**17 December 2006**

CRGref: 06689 Letter 17\_12\_06

**GATEWAY BALLINA RESPONSE TO SUBMISSIONS – BALLINA COUNCIL AND  
DEPARTMENT OF PLANNING**

- The Sketch below marks the logger location

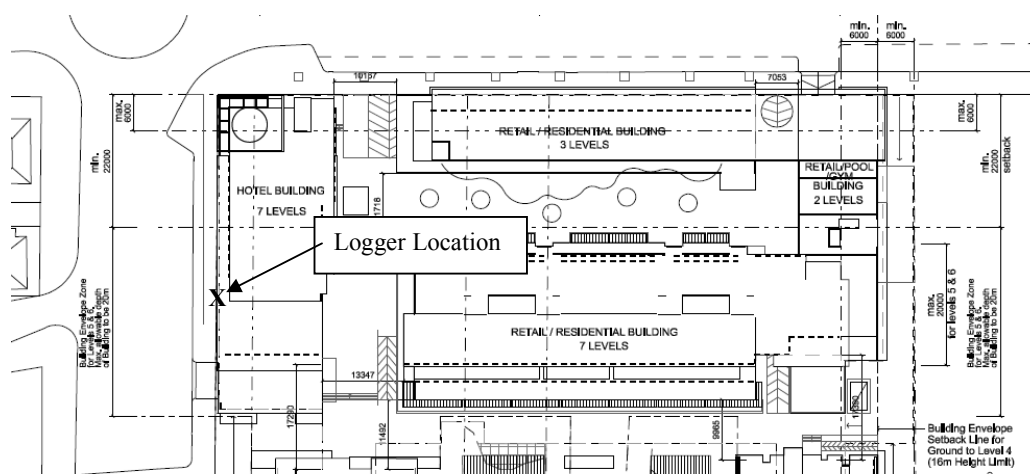
1. Monitoring period conducted over three (3) days and not the standard seven (7) days as outlined in 3.5 of the Industrial Noise Policy (INP) NSW EPA 2000. Section 3.5 however does state, *that in areas where the background noise levels are affected significantly by nearby road traffic with regular daily pattern, three (3) days worth of valid data may be sufficient. However, care should be exercised in assuming a pattern of noise levels in an area. It is recommended that, where any doubt exists, the full week's monitoring should be performed.* The subject ENIA does not justify why the three (3) days worth of data is valid for this development.

- The noise logger was only deployed for 3 week days (no weekend days/nights) and no operator-attended monitoring appears to have been conducted.

The DEC's *Industrial Noise Policy* requires equivalent to one week's worth of valid data covering the days and times of operation of the development. Continuous sampling should be accompanied by periods of operator-attended monitoring. In areas where the background noise levels are affected significantly by nearby road traffic with regular daily pattern, three days' worth of valid data may, in some cases, be sufficient. However, as there are commercial activities in the area which have the potential to generate more noise over the weekend (Ballina RSL, Ballina Hotel), care should be exercised in assuming a pattern of noise levels in the area. It is recommended that the full week's monitoring should be performed.

**Response** We note that the data collected was quite consistent, with little variation between days. This factor, coupled with other noise level measurements in the local area for other projects confirmed that the data collected should be sufficient. This point notwithstanding, we propose to undertake further monitoring at the site.
